**City of Portland, Maine – Building or Use Permit Application** 389 Congress Street, 04101, Tel: (207) 874-8703, FAX: 874-8716

Location of Construction: 136-138 Pleasant Ave.		* Owner: Michael & Barbara Stoddard		Phone: 761-4566	Permit No: <b>081462</b>
Owner Address:	Lessee/Buyer's Name:	Phone:	BusinessName:		
Contractor Name: Greg Carmichael 541 East Main St. Yarmouth, ME 04096	Address: Yarmouth, ME 04096	Phone: 846-3866	Permit Issued: <b>DEC 31 1998</b>		
Past Use: 2-family	Proposed Use: Same	COST OF WORK: \$ 4,000	PERMIT FEE: \$ 40.00	CITY OF PORTLAND	
Proposed Project Description: Replace decking, cracked concrete slab in basement, replace cracked foundation-portion, and replace door w/window in basement.		FIRE DEPT. <input type="checkbox"/> Approved <input type="checkbox"/> Denied	INSPECTION: Use Group R3 Type: 5B BOC 496	Zone: CBL: 131-G-004	
		Signature: _____		Signature: <i>Hoffman</i>	
Permit Taken By: <u>ub</u>		PEDESTRIAN ACTIVITIES DISTRICT (P.A.D.)		Zoning Approval: <i>Final OK</i>	
		Action: <input type="checkbox"/> Approved <input type="checkbox"/> Approved with Conditions <input type="checkbox"/> Denied	Signature: _____ Date: _____		Special Zone or Reviews: <inpu

Plot Plan, 138 Pleasant Avenue, Portland  
+ Set Backs

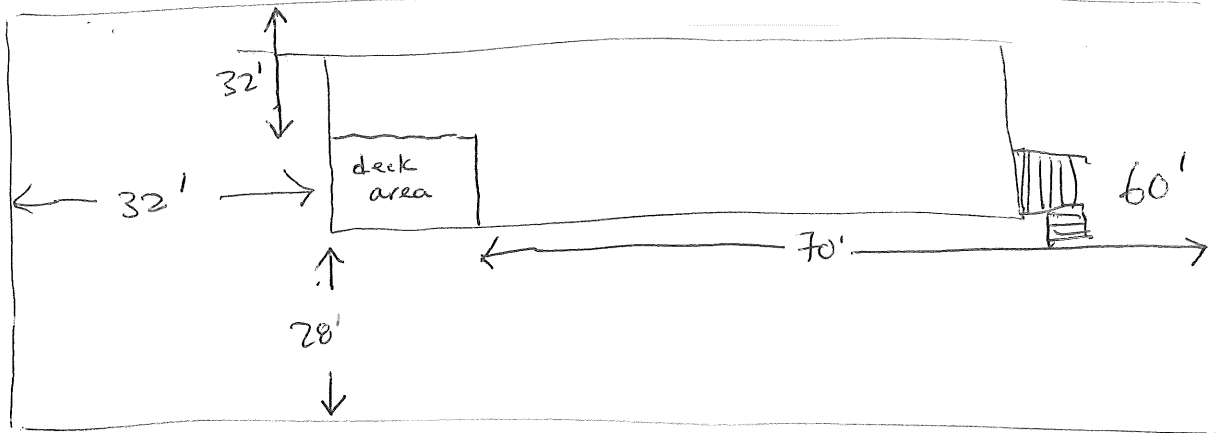
R5 Zone requires  
20' rear setback  
12' 2 story side setback -  
OK 12/30/98
